ADDENDUM No. 3
FOR
LINK – Multi-Use Development
BID PACKAGE – All Trades

Date of Issue: April 24, 2023

LINK – Addendum #3 Narrative

4/21/23

UNIT 2A
S152 1/4" = 1'-0"

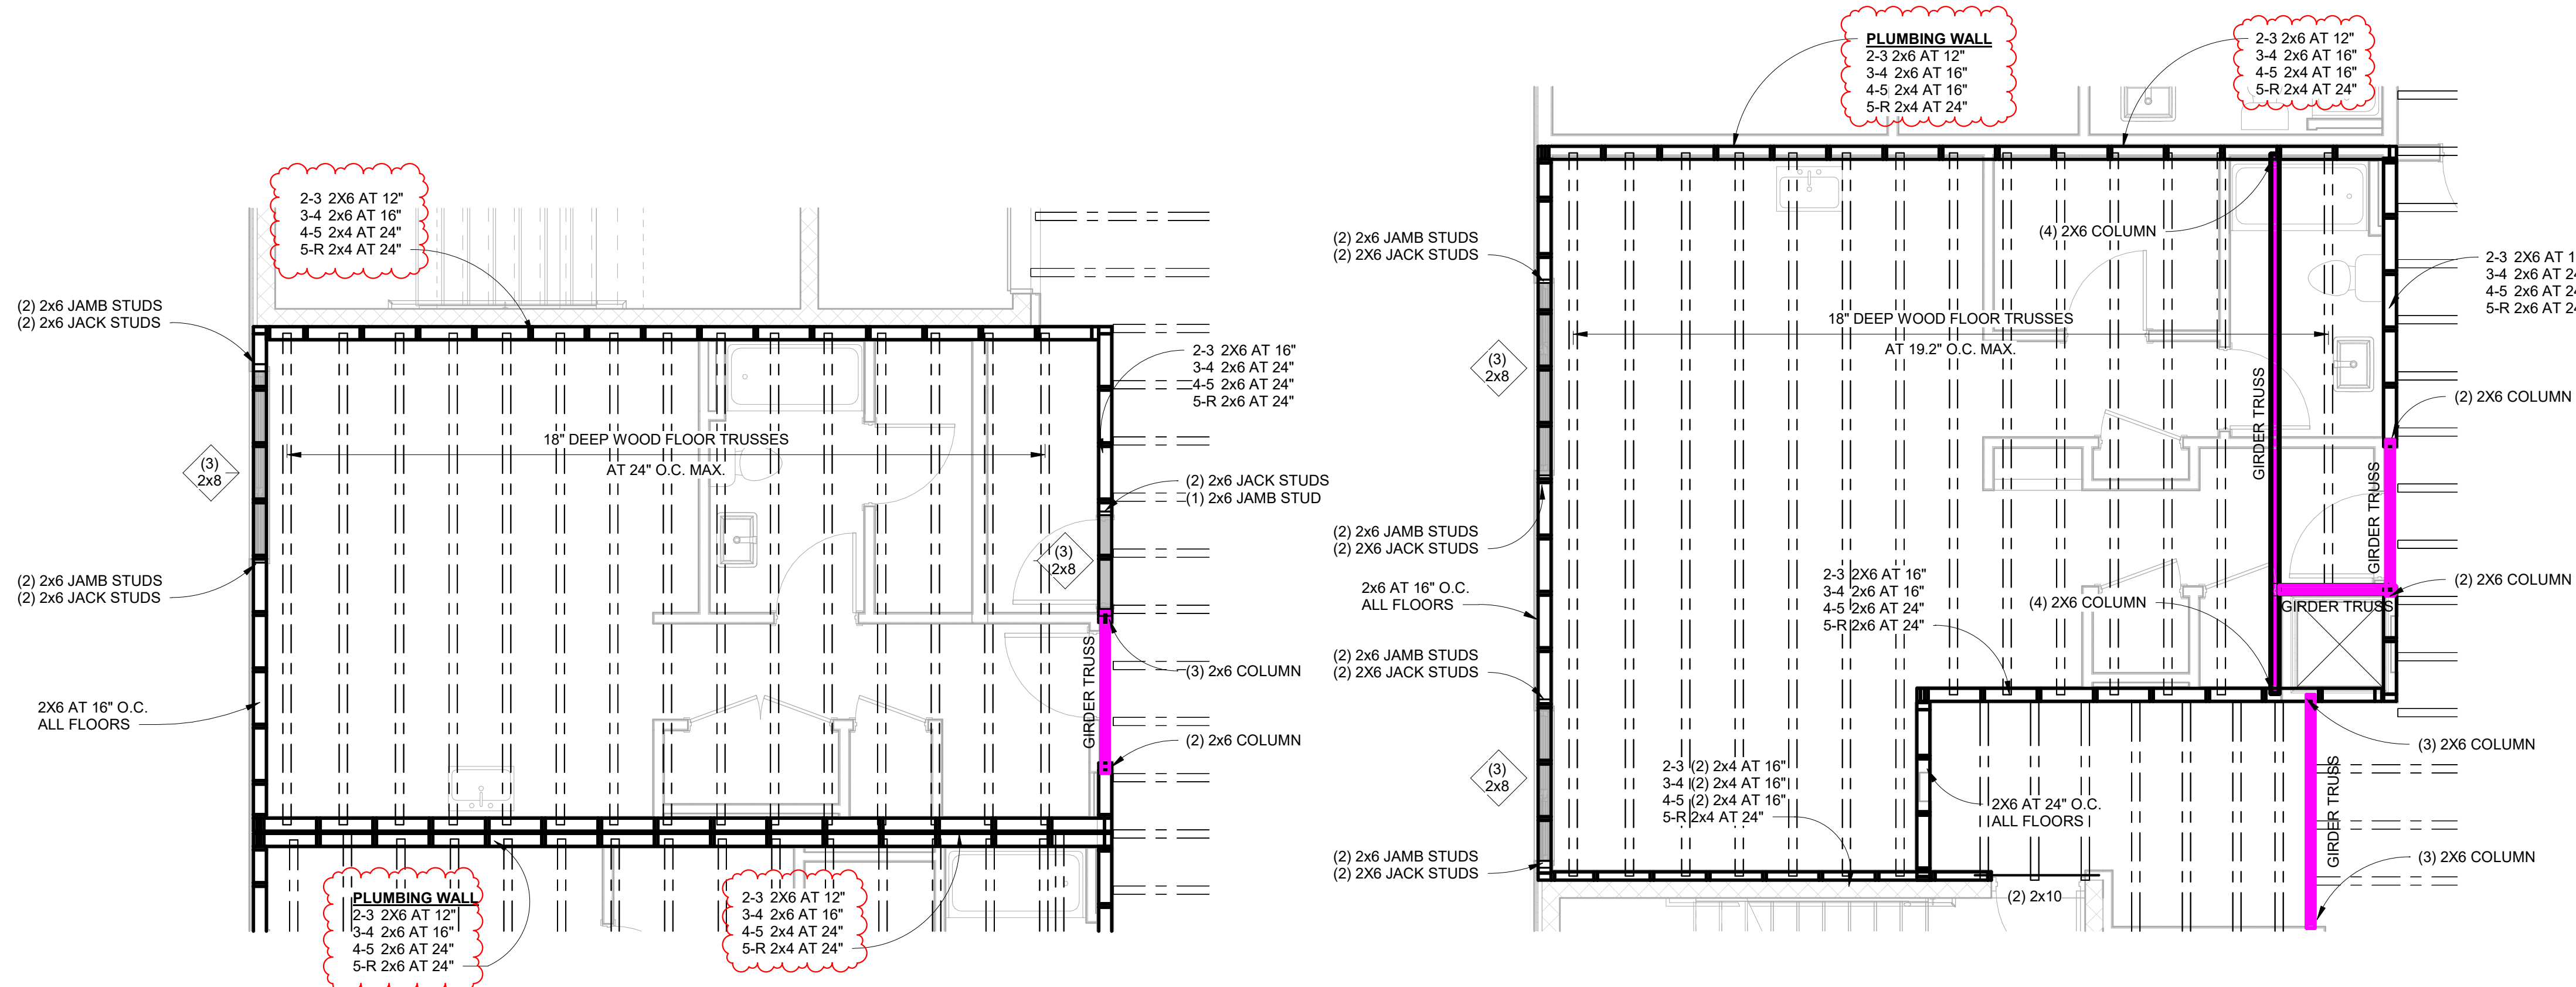
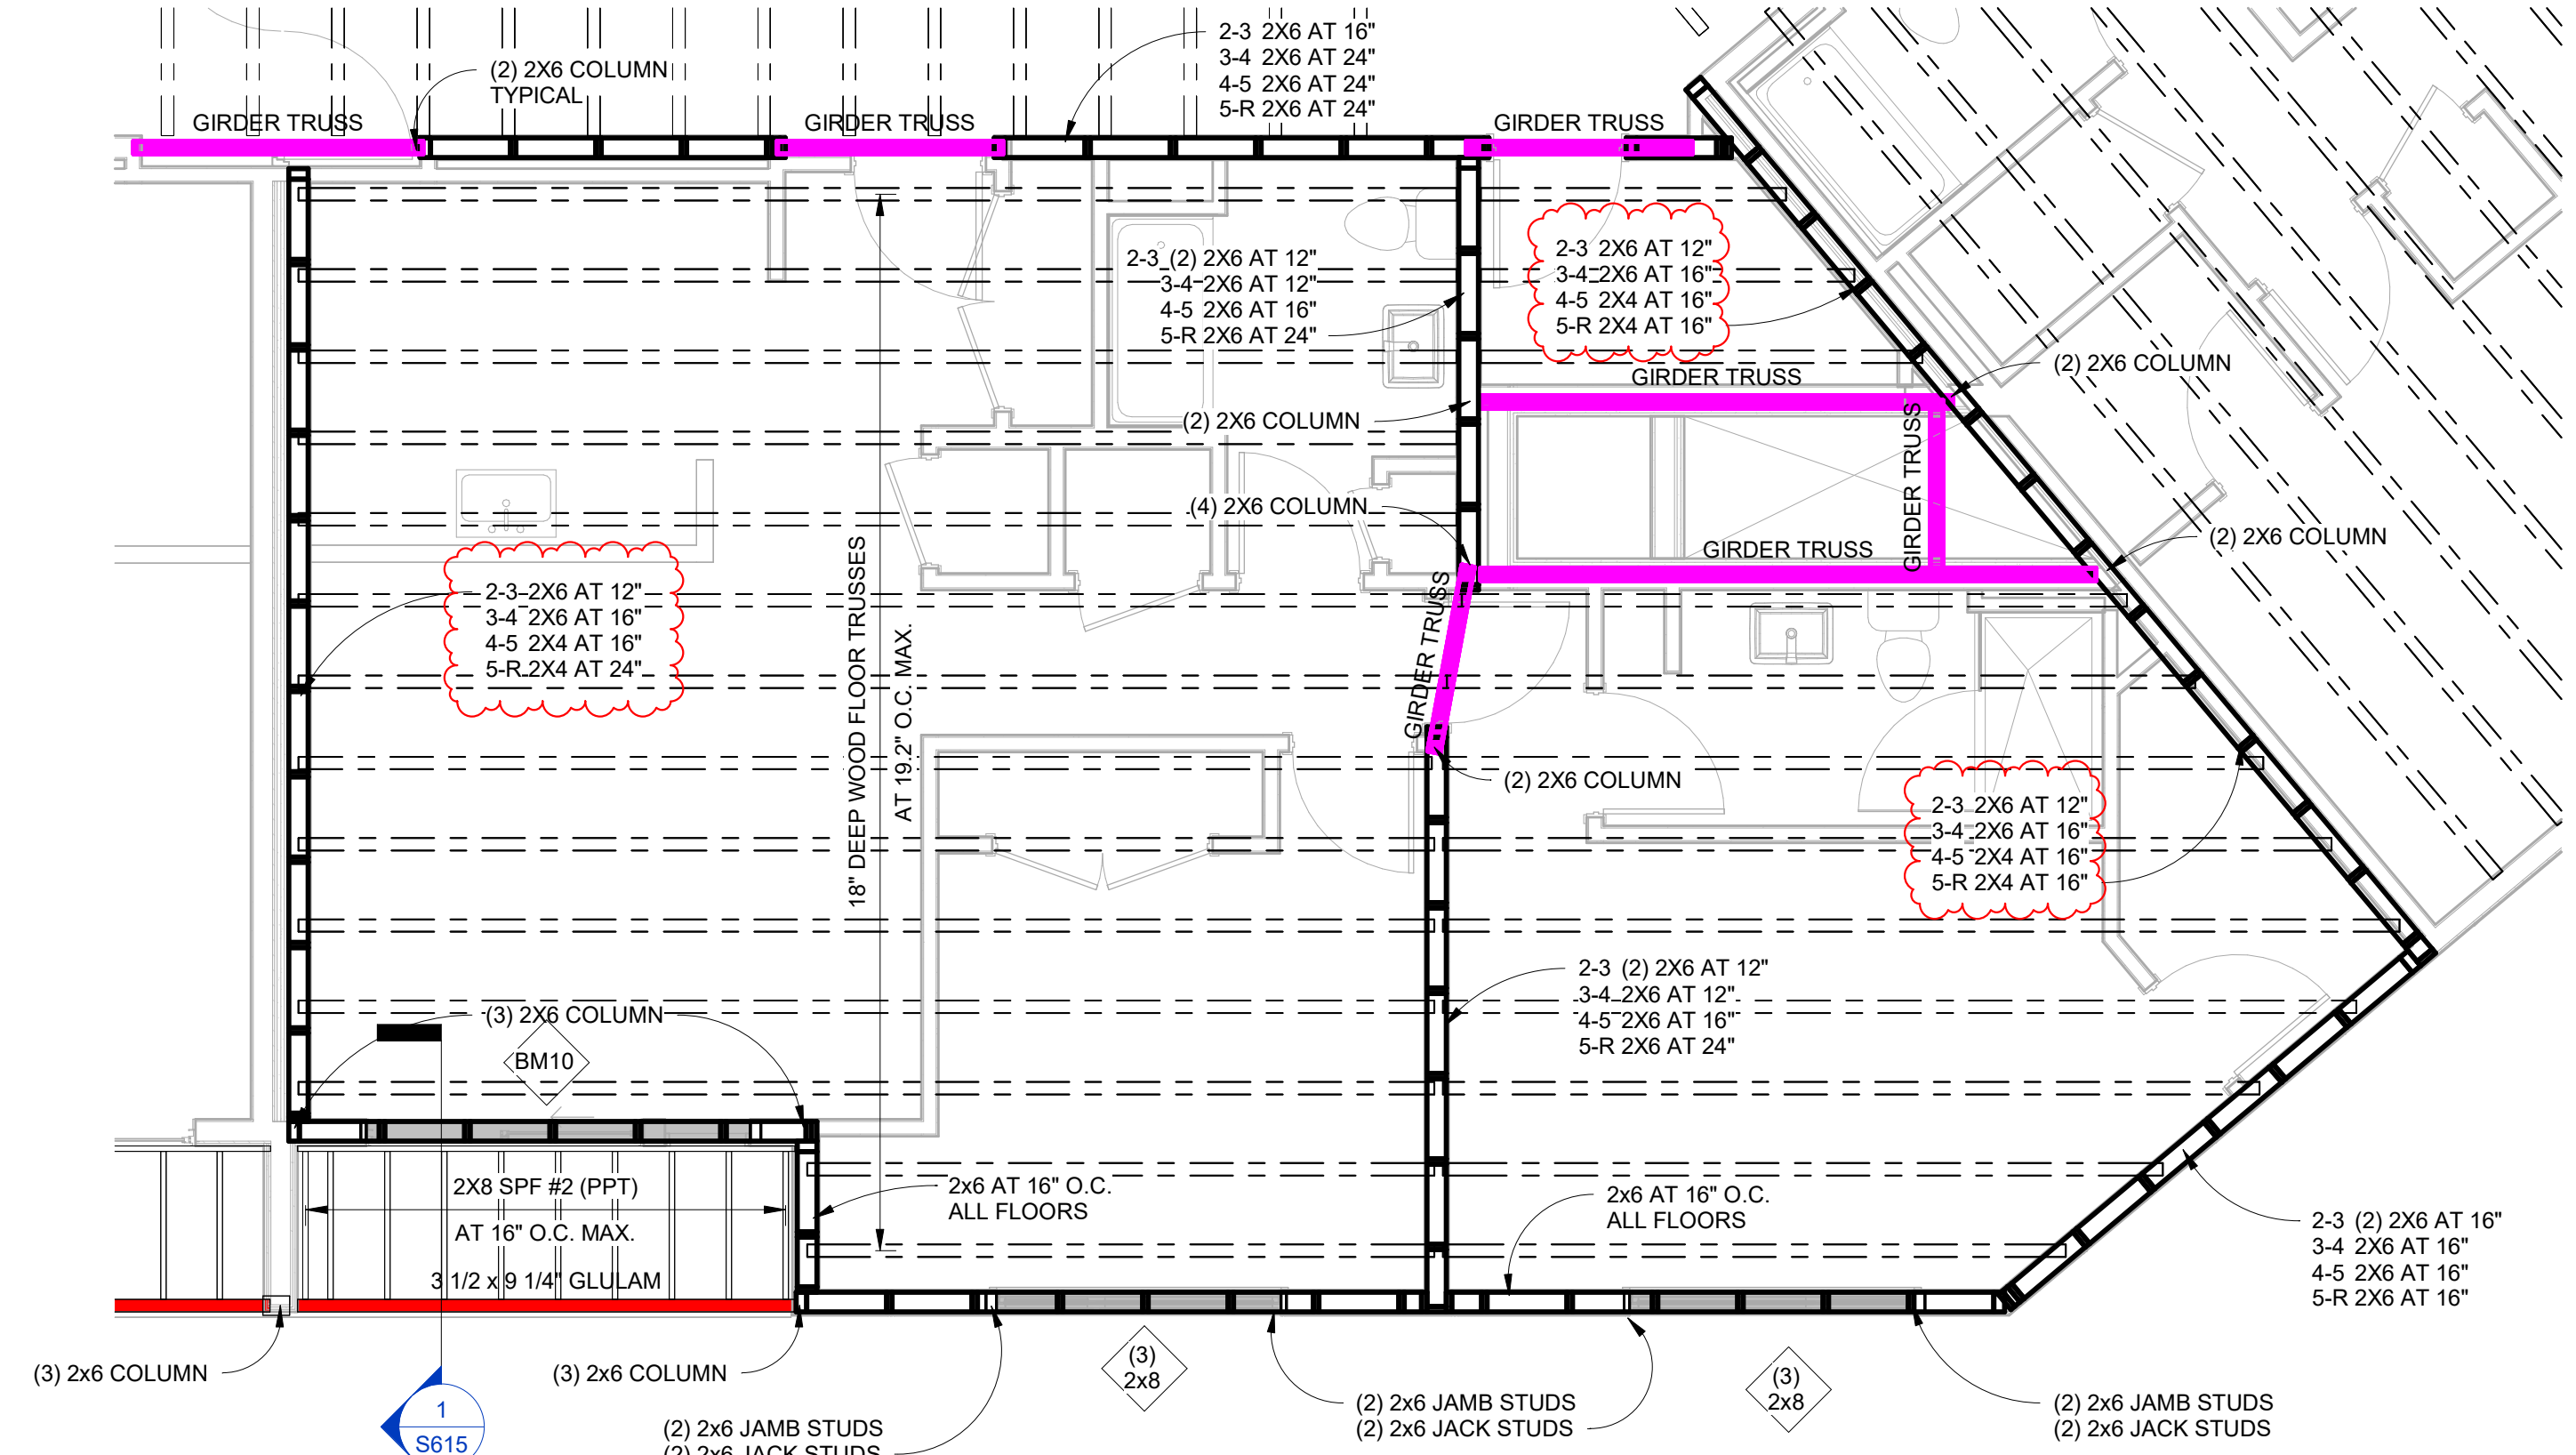
- S152
 - Revised studs at upper floor demising walls to 2x4 studs where indicated.
 - S153
 - Revised studs at upper floor demising walls to 2x4 studs where indicated.
